# UNITED STATES PATENT AND TRADEMARK OFFICE

10/707,168

| <b>Office Action Summary</b> | <b>Application No.</b><br>10/707,168   | <b>Applicant(s)</b><br>SINHA ET AL. |  |

FIG. 1

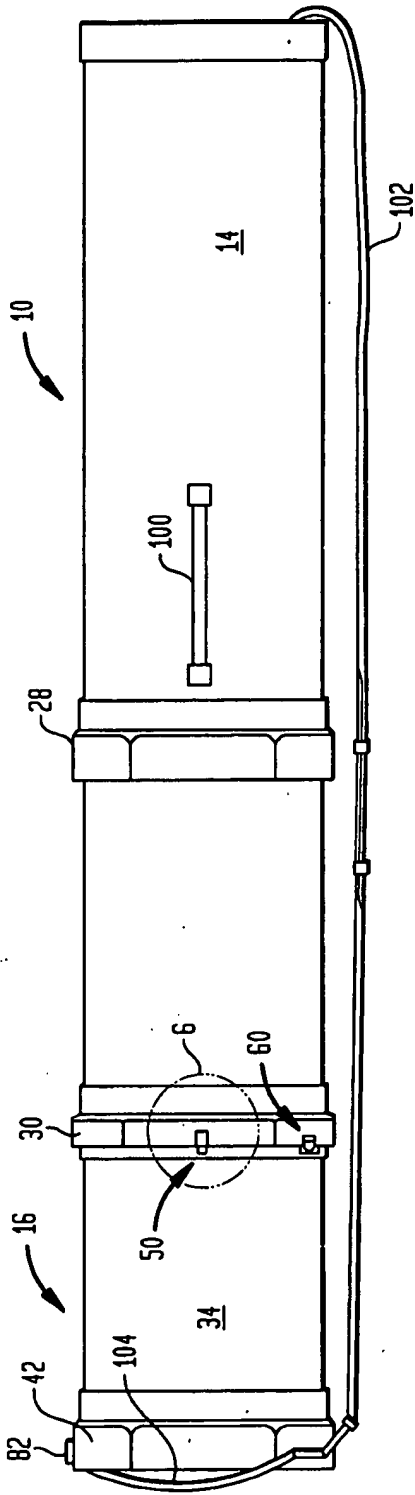
The drawings are objected to under 37 CFR 1.83(a). The drawings must show every feature of the invention specified in the claims. Therefore, the first and second bottom members of claim 1 and the octagonal impact rings of claim 7 must be shown or the feature(s) canceled from the claim(s). No new matter should be entered.

The amendment to the drawings filed 12/04/03 is objected to under 35 U.S.C. 132(a) because it introduces new matter into the disclosure. 35 U.S.C. 132(a) states that no amendment shall introduce new matter into the disclosure of the invention. The added material which is not supported by the original disclosure is as follows: The elimination of an octagonal bottom cap ring and connected shoulder strap in the amended drawings is considered new matter.

DRAWINGS NOT APPROVED FOR ENTRY

Applicant is required to cancel the new matter in the reply to this Office Action.
